# United States Patent and Trademark Office

APPLICATION NO. FILING DATE		FIRST NAMED INVENTOR	ATTORNEY DOCKET NO.	CONFIRMATION NO.	
09/785,785 02/16/2001		Leon P. Janik	STAN/322/US 3391		
2543	7590 05/11/2004		EXAMINER		
	& RISTAS LLP	CECIL, TERRY K			
750 MAIN ST SUITE 1400	REET	ART UNIT	PAPER NUMBER		
HARTFORD,	CT 06103	1723

#### **DETAILED ACTION**

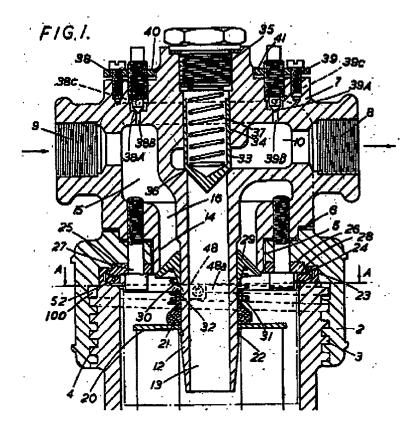
Janik teaches a base module that includes body 12 and a communication module 18. As shown in e.g. figure 3, the round locating ring (skirt) of the communication module is received in the round aperture of the coupling plate of the body. The communication module and the body are then joined by fastening means (see claim 5 of the reference). The angular orientation shown in the drawings of the joined parts is taken as being the "selected" angular orientation as claimed [as in claims 1 and 2]. Janik does not teach the body to include a lip extending coaxially with the central opening thereof and mating with the skirt.

As shown above, Le Clair teaches a body 2 having a lip that extends away from the receptacle for mating closely with a "skirt" of the communication module 7 to define an annular interface (the examiner considers the "annular interface" to be the contacting surface between the body

and module that extends from the portion intersected by the leader of reference no. 6 to the portion intersecting the leader of reference no. 5)[as in claims 1-3]. It is considered that it would have been obvious to one ordinarily skilled in the art at the time of the invention to have the body of Janik to include the lip of Le Clair for mating with the skirt of Janik, since Le Clair teaches the benefit of a configuration for mating/locating a body to a communication module (e.g. by screws/locating ring, as desired by Janik) in an apparatus for use in the same environment as Janik—filtration of fuel.

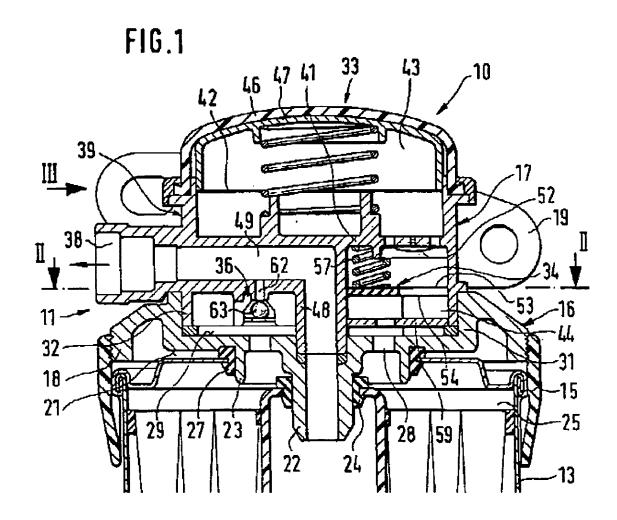
- Concerning applicant's argument about the angular orientation (pages 7-8), it is pointed out applicants claim 1 requires only that the module and body to fixed at a single angular orientation (the parts cannot be fixed together at more that one angular orientation at a time). The examiner contends that the steps argued by the applicants to chose an orientation before fixing the parts together fails to further structurally define the invention. However, it is pointed out that since both the skirt and the lip are round they would have the ability to mate at a plurality of angular orientations before being fixed.

- As explained above, the new mounting bracket limitations are already taught by Janik. It is noted that applicant's claims do not limit that bracket such that it cannot *also* extend axially above the lip.
